City of Mount Vernon
Design Review Board
Minutes – August 19, 2021

PUBLIC MEETING FOR PROPOSED FAÇADE AND SITE CHANGES TO 508 S 2ND STREET

PERMIT NUMBER:	PLAN21-0294		
PROJECT ADDRESS:	508 S 2 nd Street	PROJECT PARCEL NUMBERS:	P52080
APPLICANT:	Mark Christ		
PROJECT DESCRIPTION:	Phased project to result in 1,820 s.f. of professional office space, seven new apartments (7,946 s.f. of interior remodeling will create five (5) of the units and a 3,196 s.f. addition to the third floor will create the additional two (2) units), and new improvements including: an apartment lobby, elevator, outdoor roof deck, parking areas, dumpster enclosure, common outdoor space, and landscaping.		
APPLICABLE MVMC	MVMC CHAPTERS 17.70, 17.48, 17.84, 17.93 AND CHAPTER 14.05

Improvements to 508 2nd Street
for RPI Mount Vernon LLC

Site Plan
1"=10'-0"

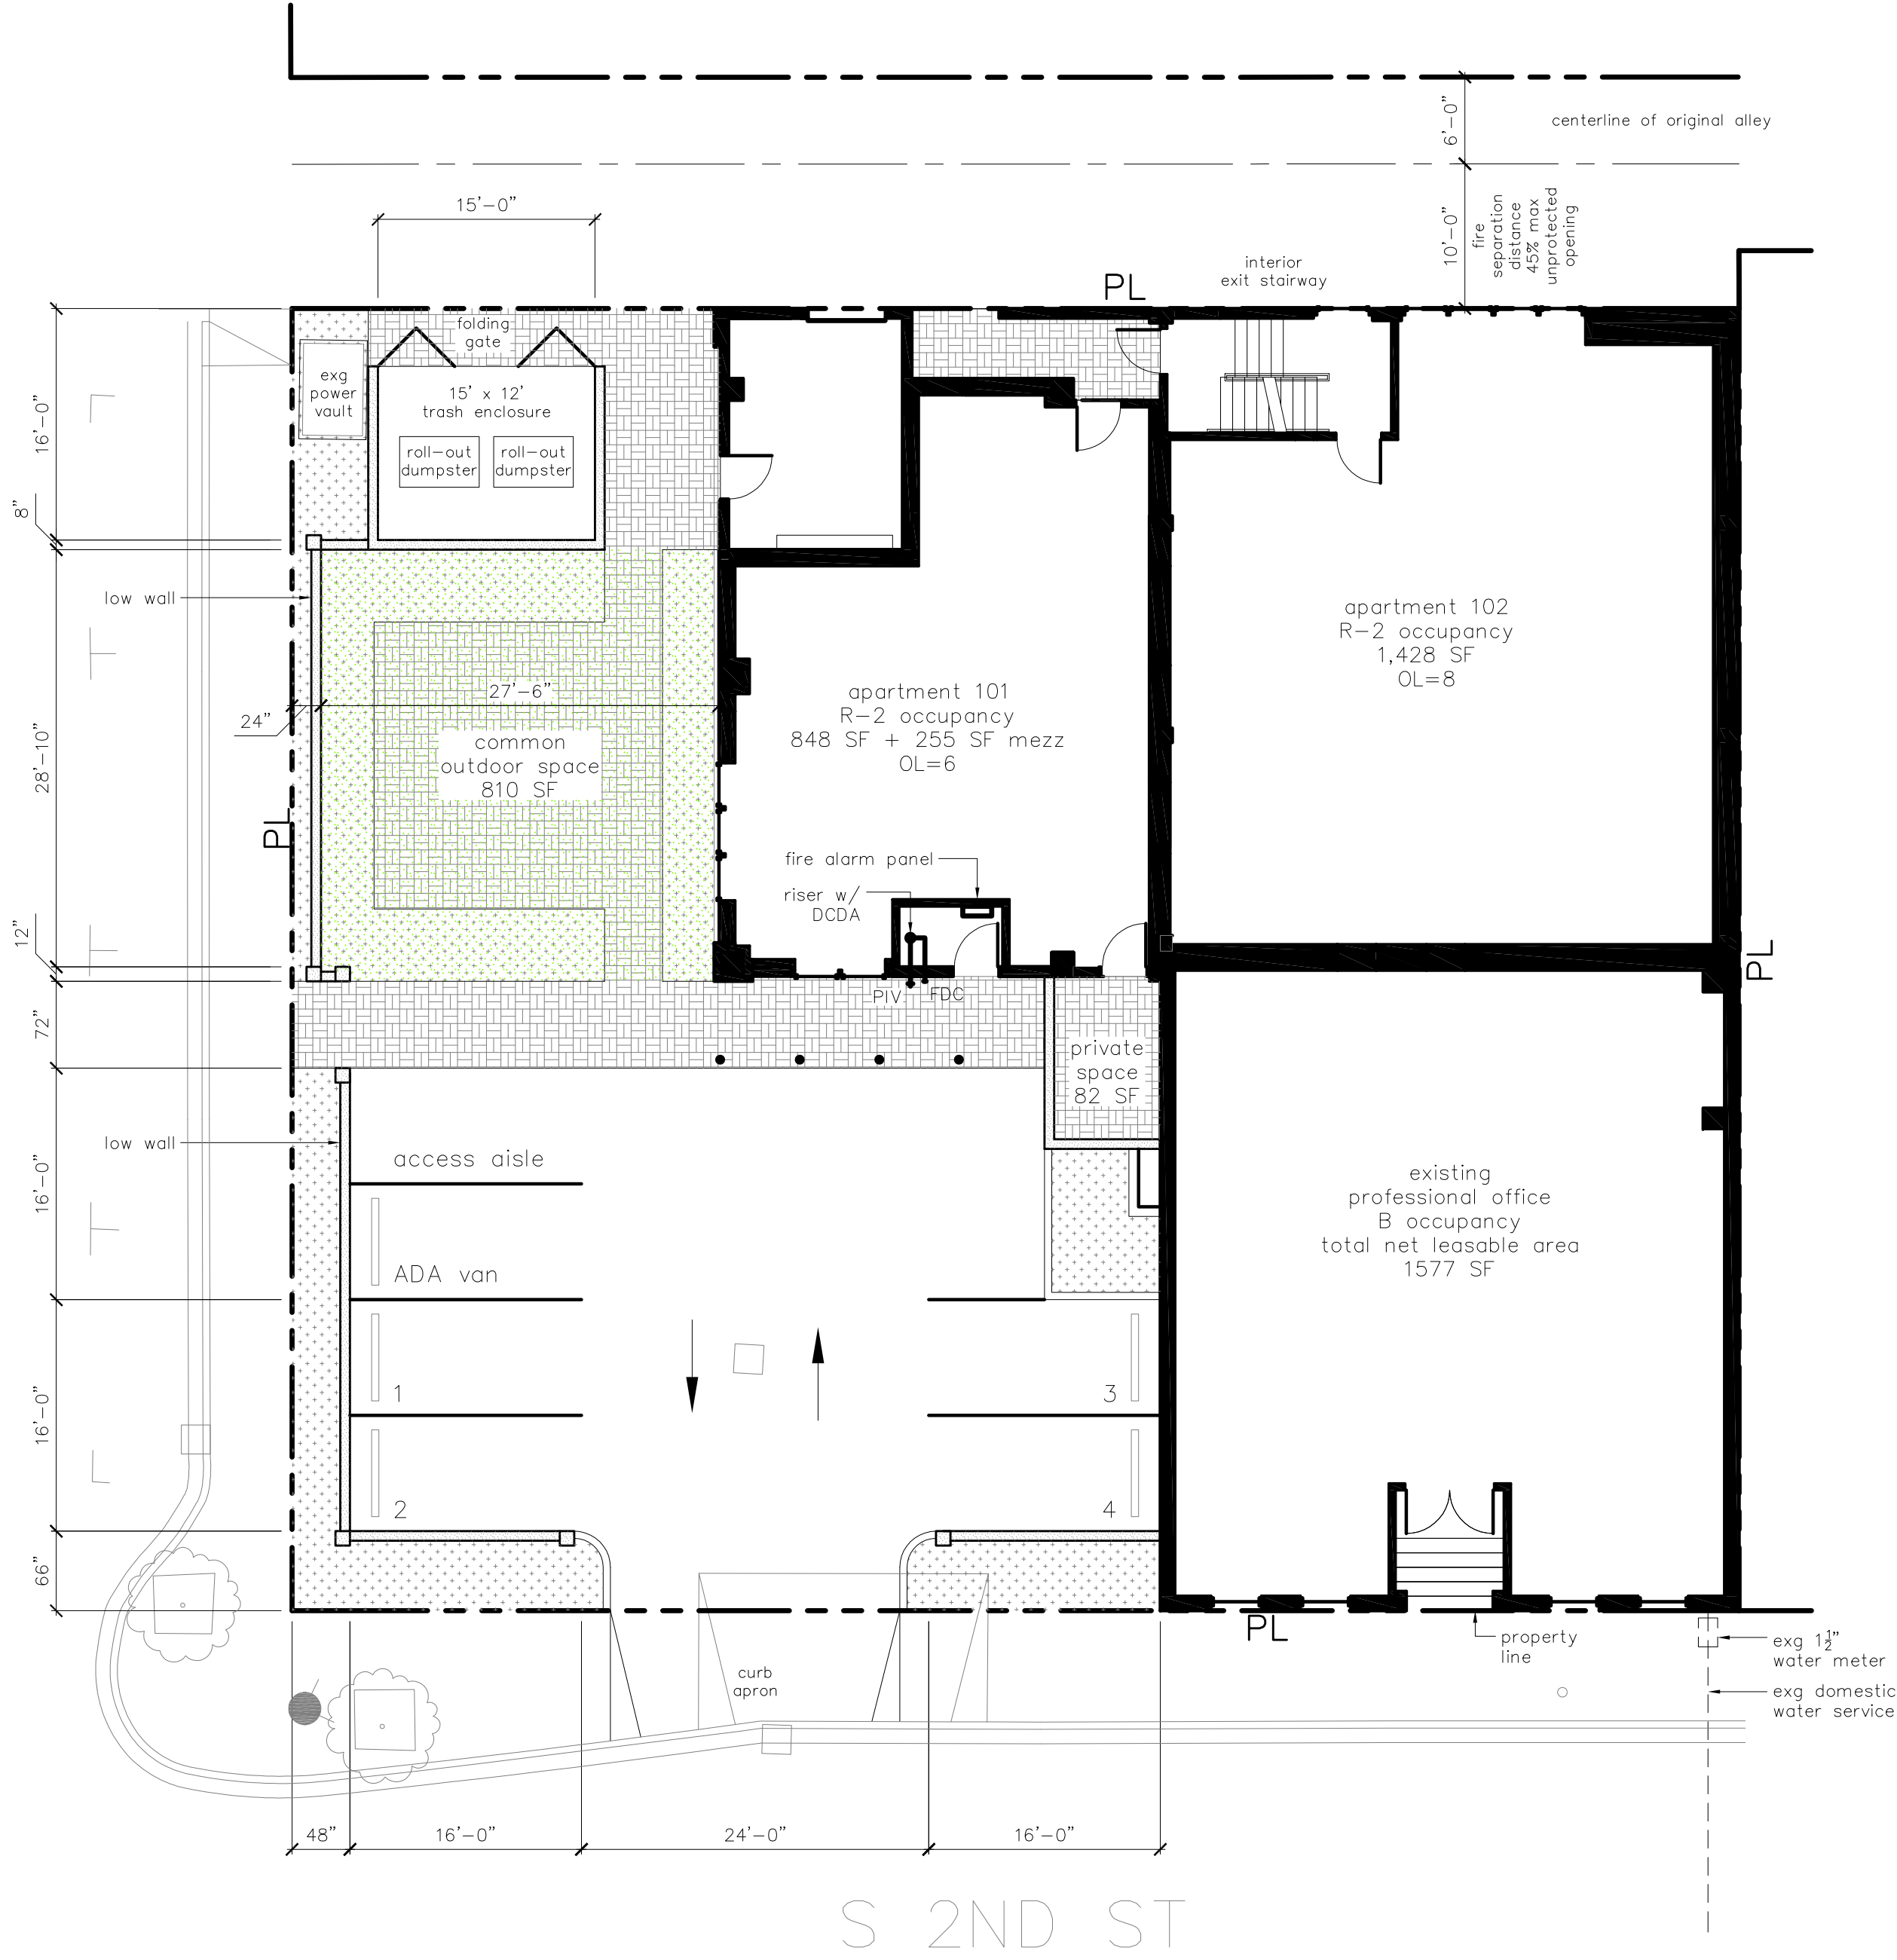
The plans submitted identify a 4-foot landscape area along the west side of the site abutting South 2nd Street and landscaping strips along the north side of the site abutting West Gates Street that vary between 3 feet and 5.5 feet.

The two street trees abutting South 2nd Street will need be evaluated by the City's arborist and the Applicant will need to replace both trees if the City's arborist finds these trees are not in good health. In addition, a street will need to be installed near the northeast corner of the site where a tree has been removed.

3. The Board recommends the City's arborist review and approve the landscaping plans. The Applicant will be required to amend these plans as recommended by the City's arborist.
